寄件者: AI TSANG <[REDACTED]>
寄件日期: 2026年10月05日星期一 14:29
收件者: Adrian Tsz Hin TAM/PLAND
主旨: TKLN 143 response TD and LD and clarification
附件: 143 response to td comment (2).pdf; 143 response to LD comment.pdf

Response to LD comment

Swept Path Plan

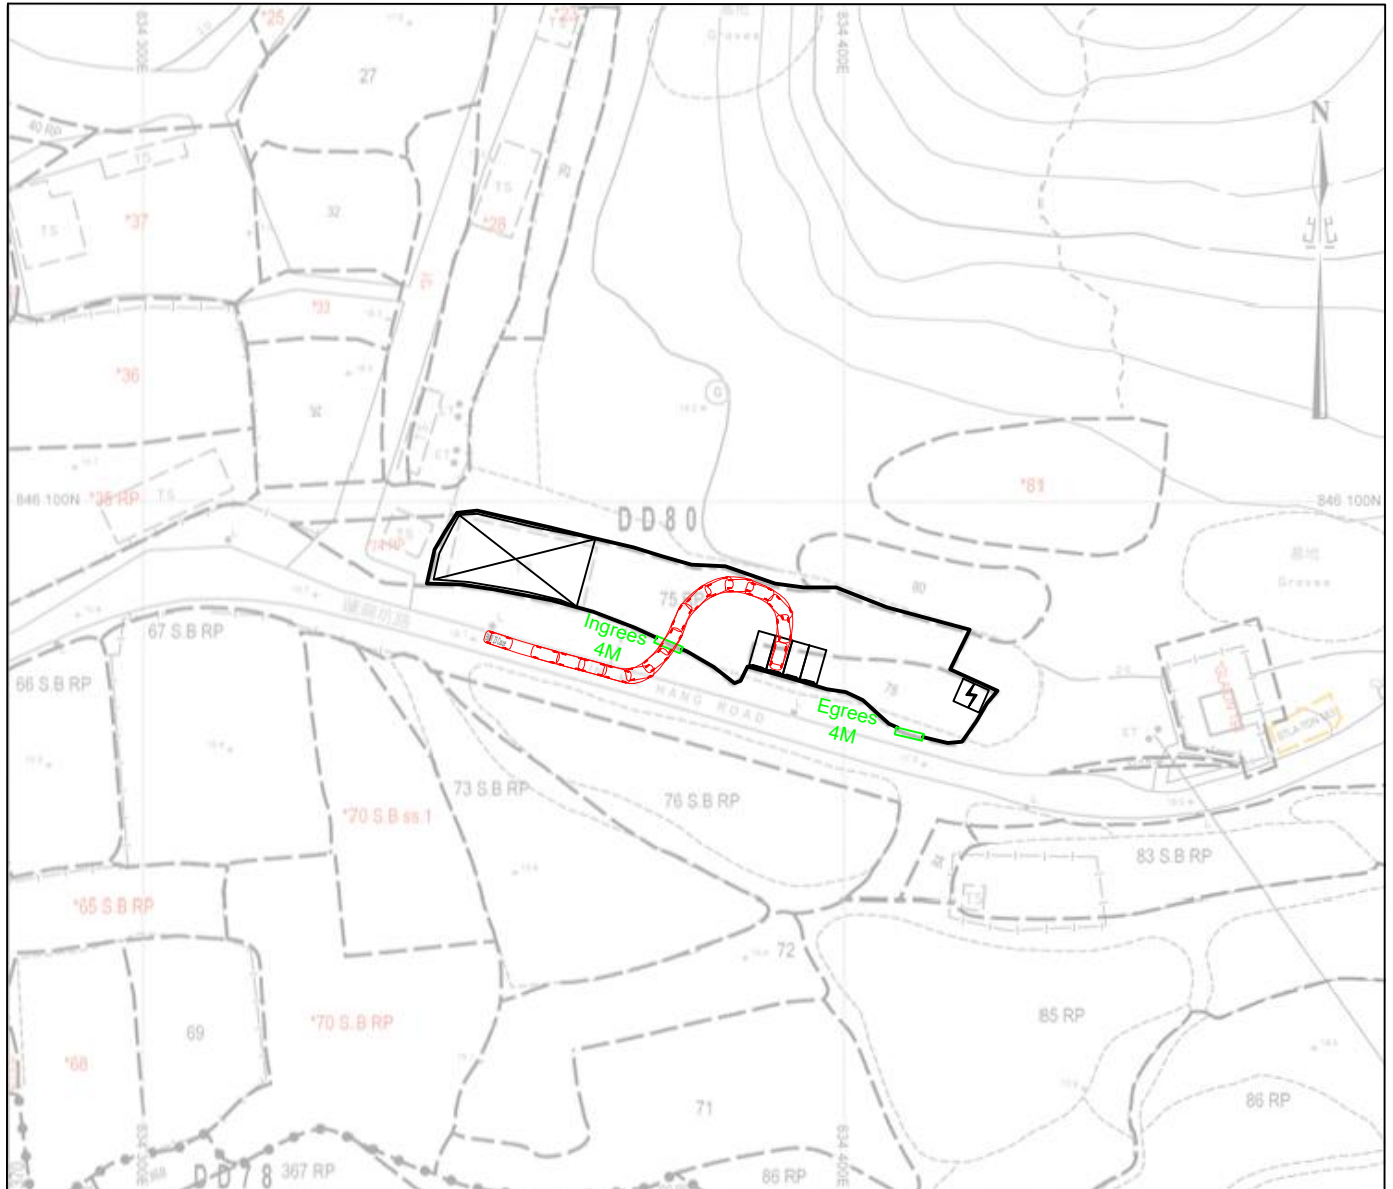
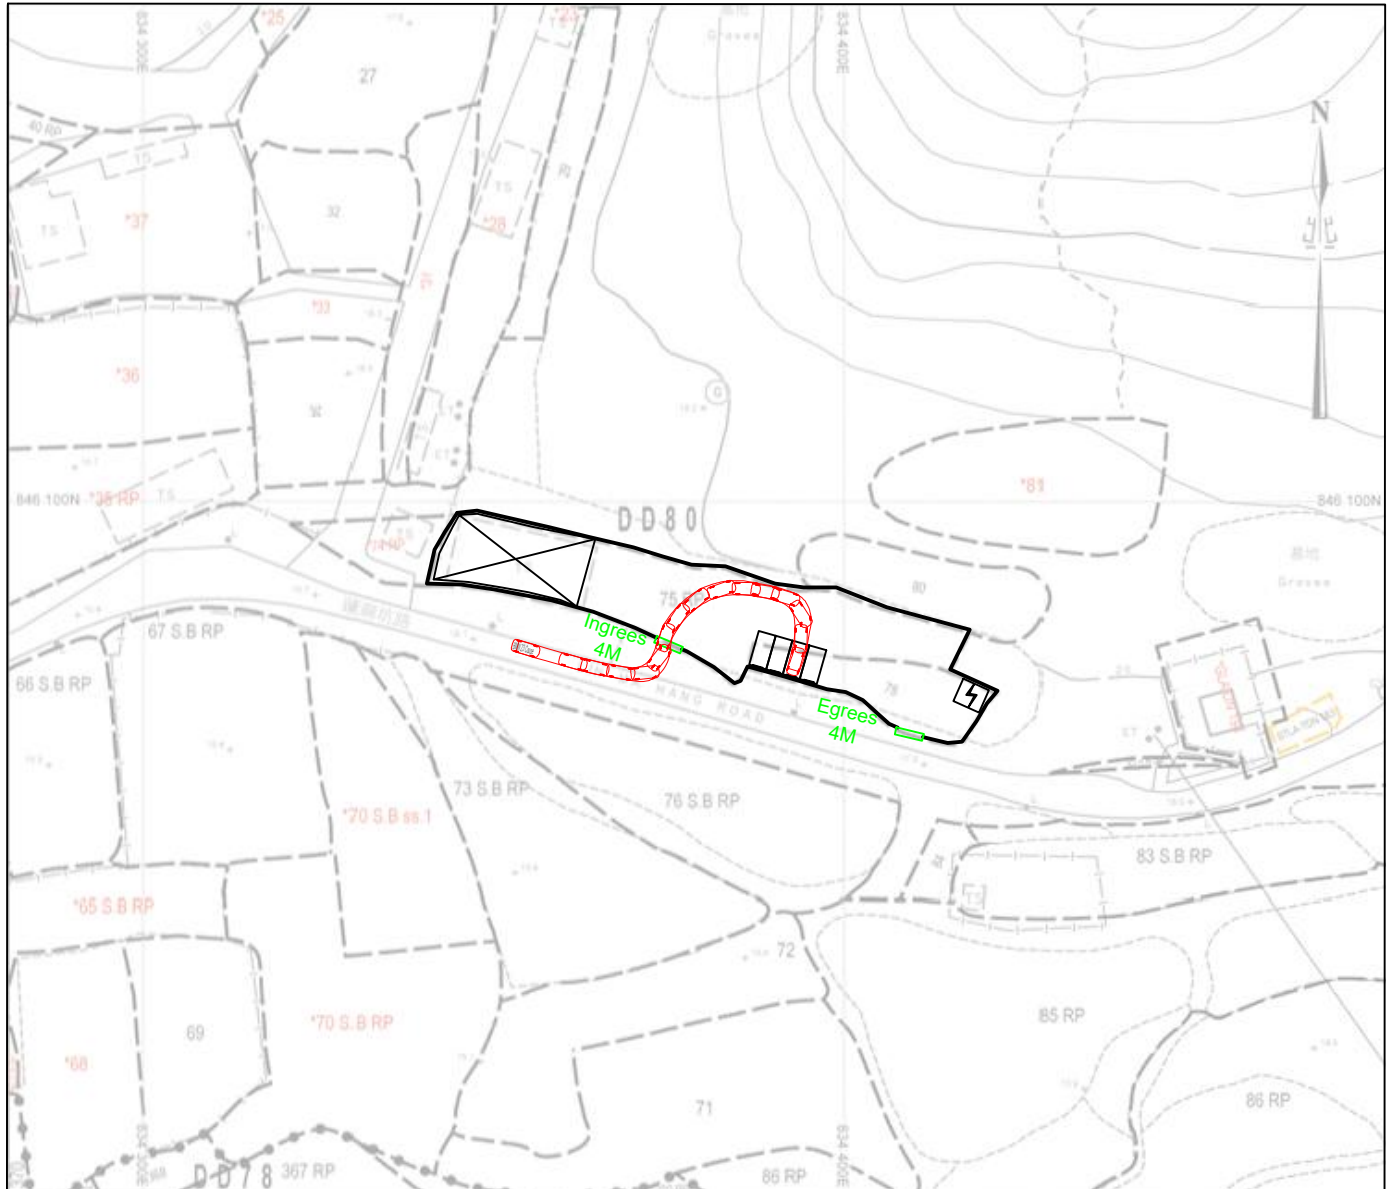
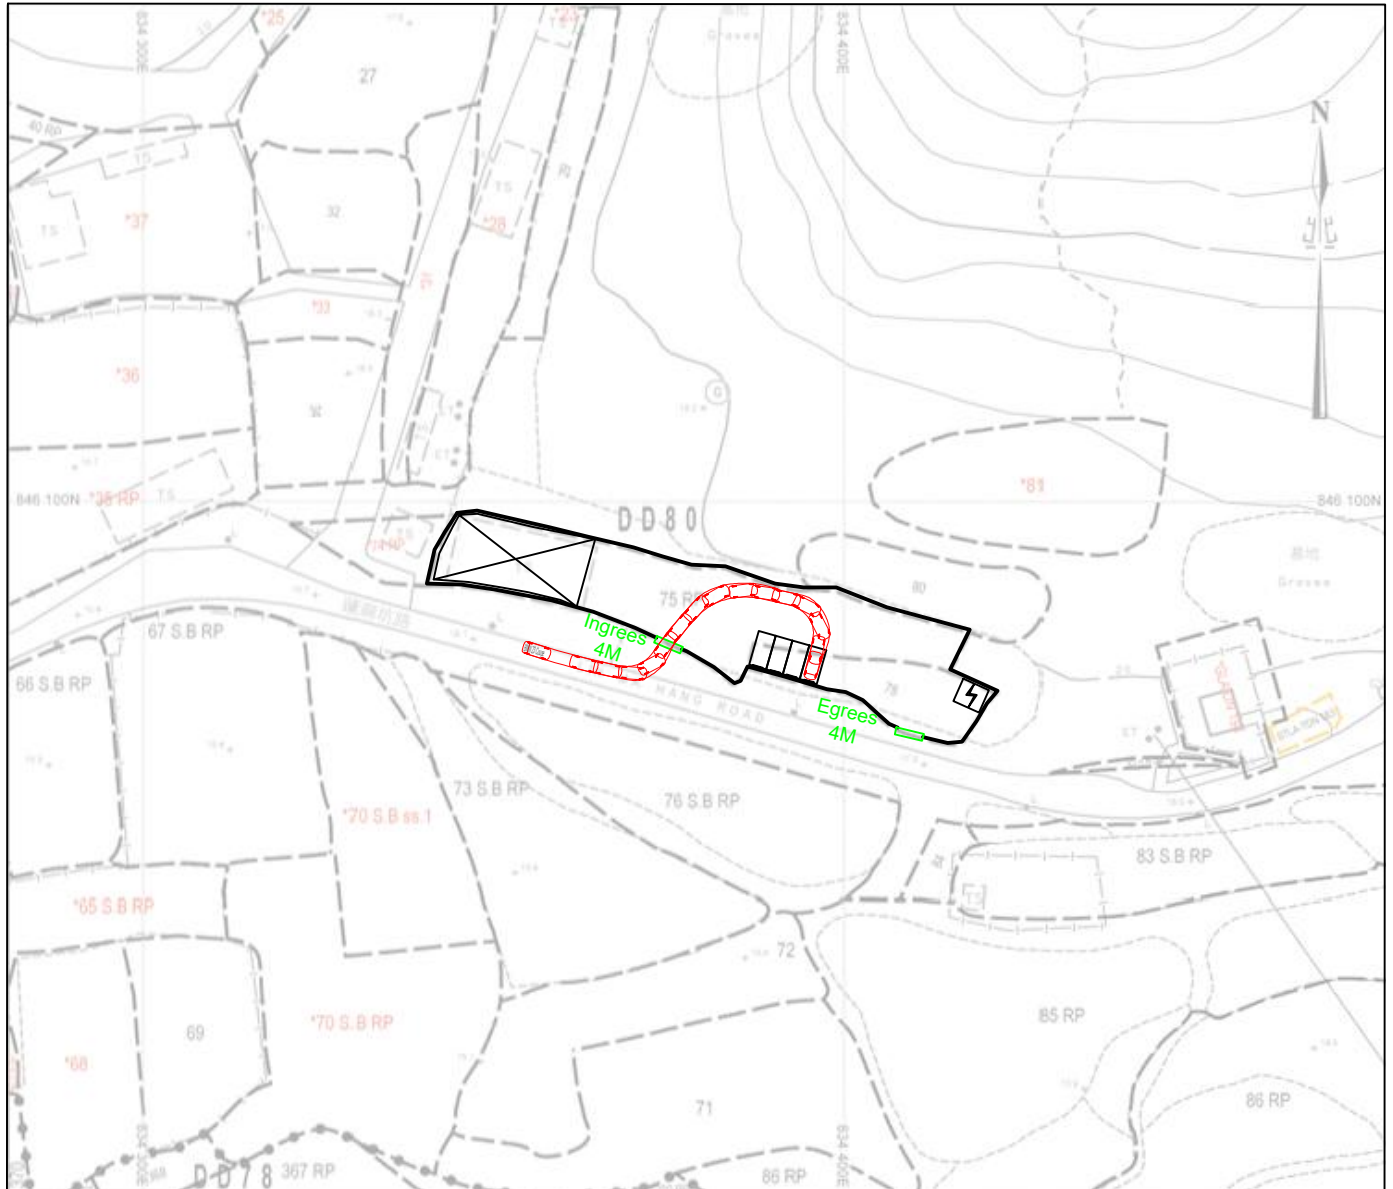
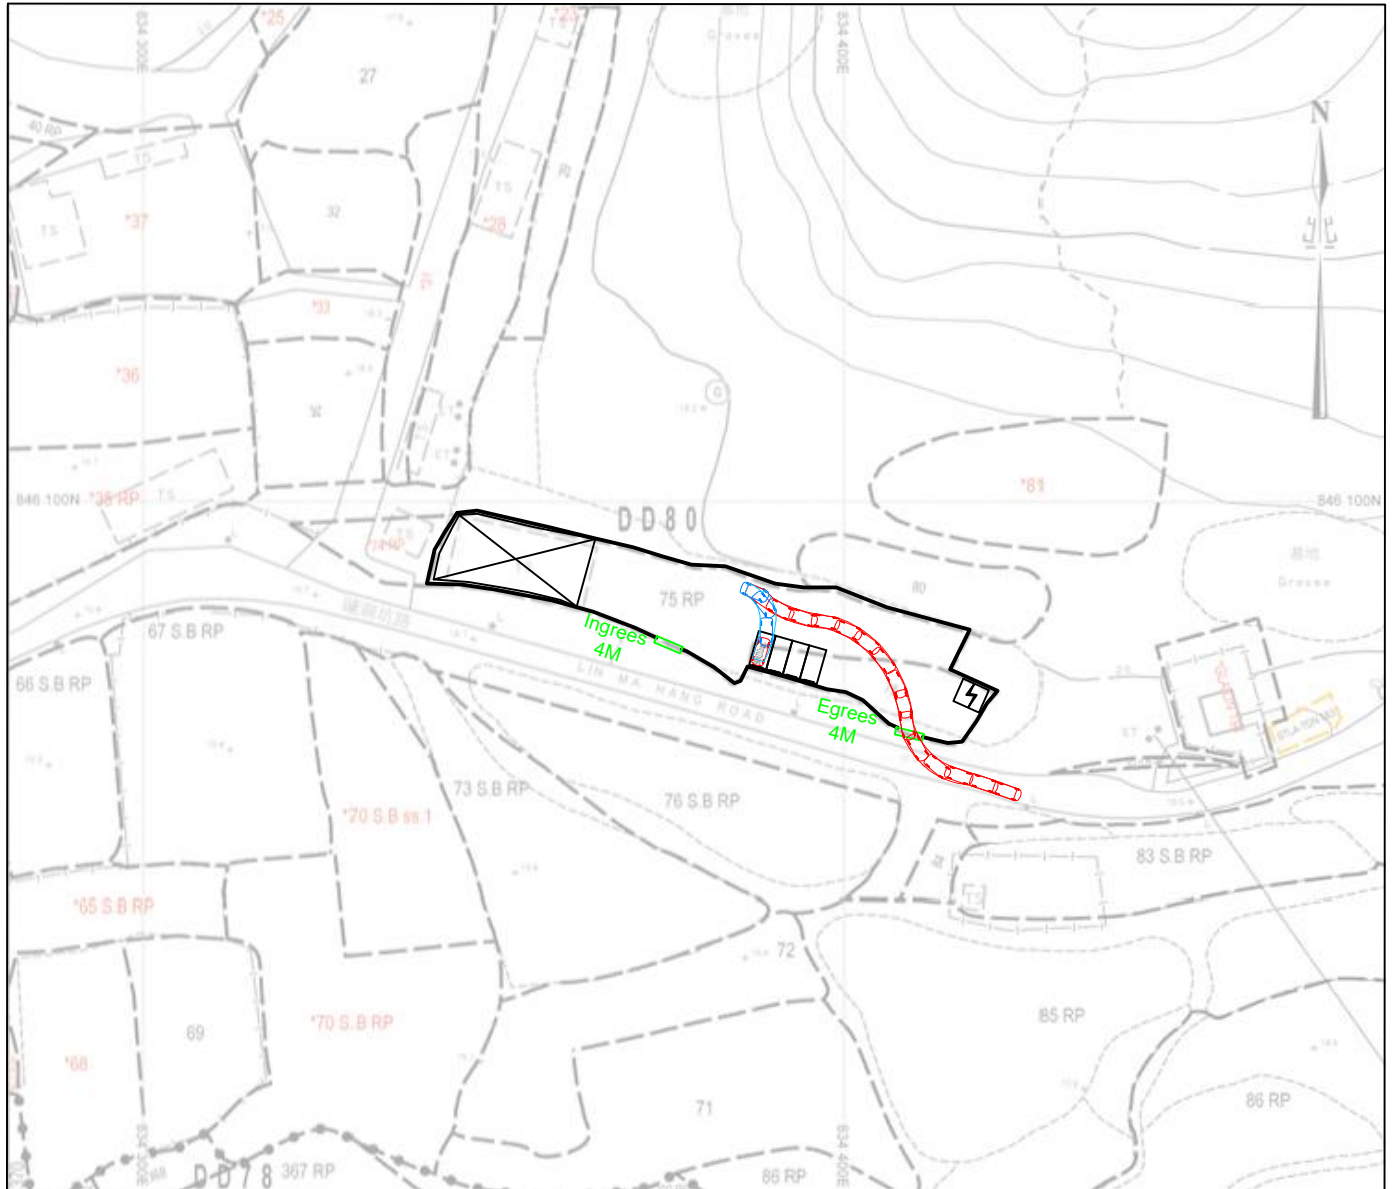
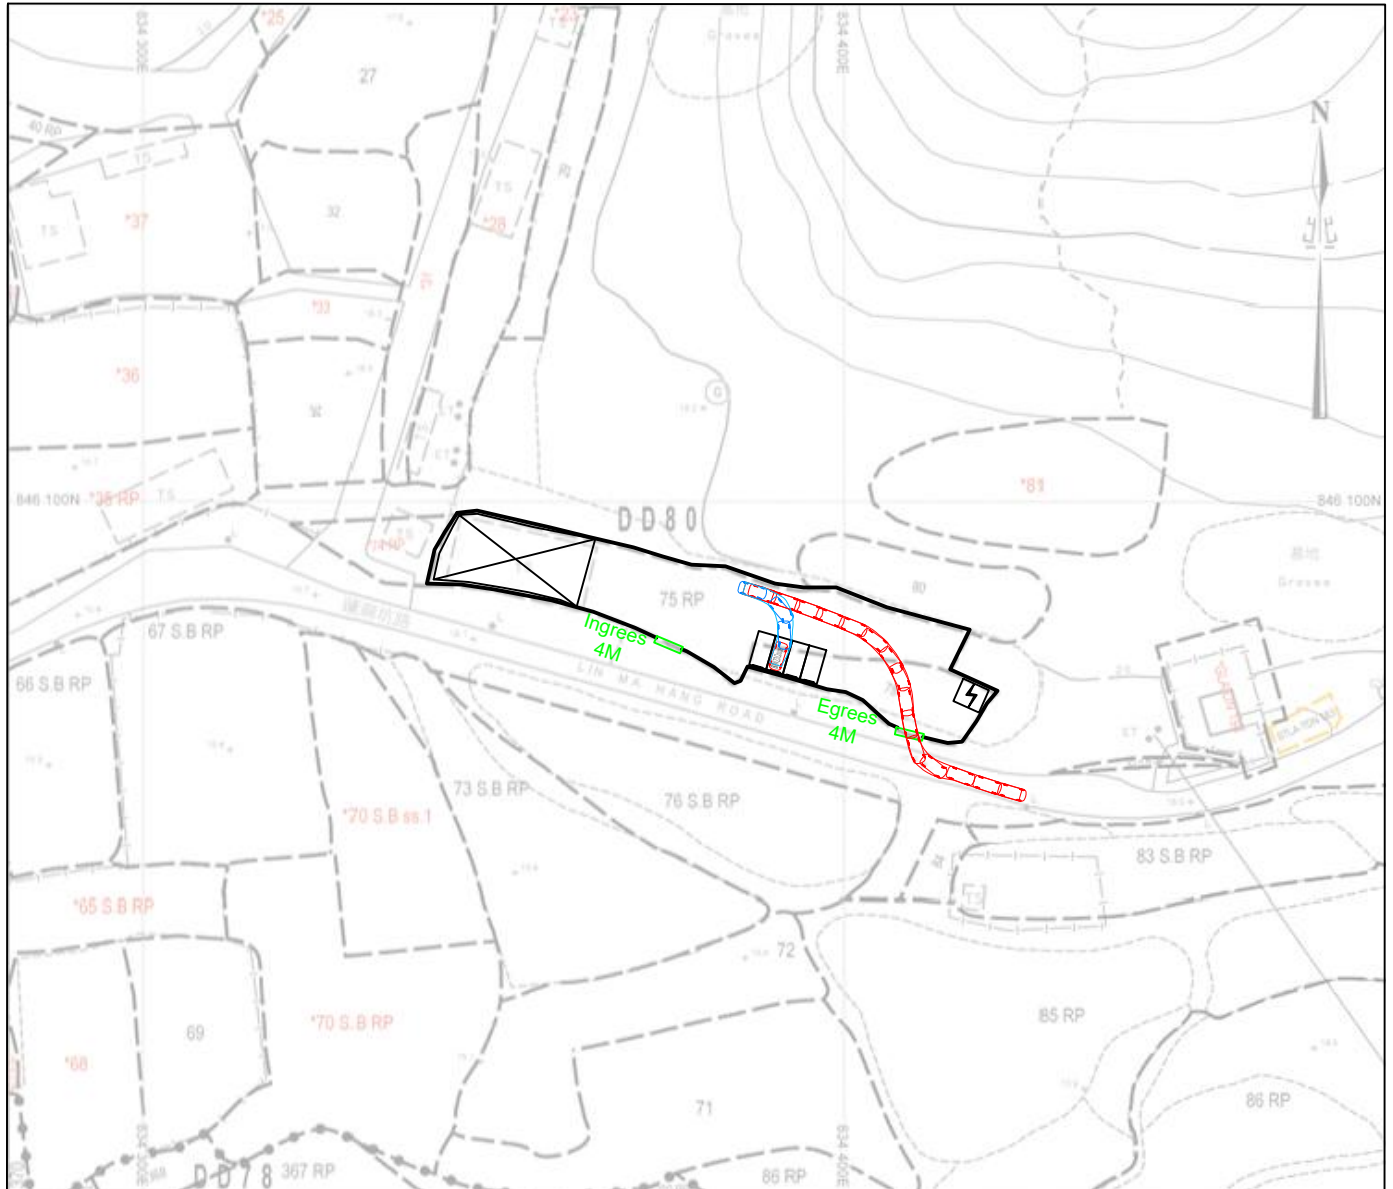
Comment 3
the applicant shall demonstrate the satisfactory maneuvering of the vehicles entering and exiting the application site, maneuvering within the application site and into/out of the parking preferably using the swept path analysis; and
Response
Please refer to swept path plan

- 1.3. The application site has 1 ingress and 1 egress, with a width of 4 meters connecting to Lin Ma Hang Road.
- 1.4. Swept Path Analysis has been conducted for the access points and passages. The site access points and parking arrangements are sufficient for safe maneuvering and operation.
